Service Bulletin
Narrowband Customer Bulletin
RT-1830 Version and Power Supply Obsolescence

Document No.1346073, Rev. 003

06 August 2020

Figure 3. Pentair Chassis Label

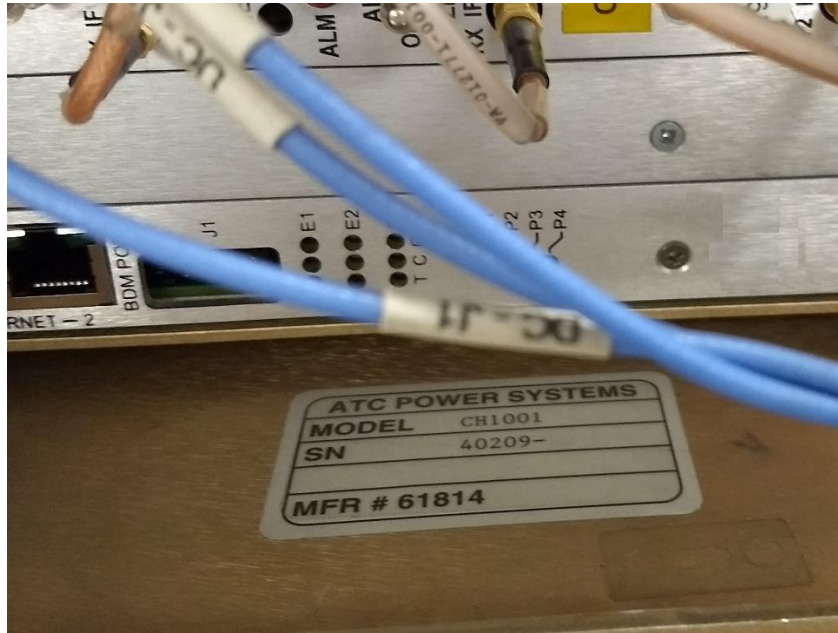
i)   The Pentair/nVent chassis can be identified by opening the front access panel and looking inside at the bottom of the module slots. The label appears as shown below:
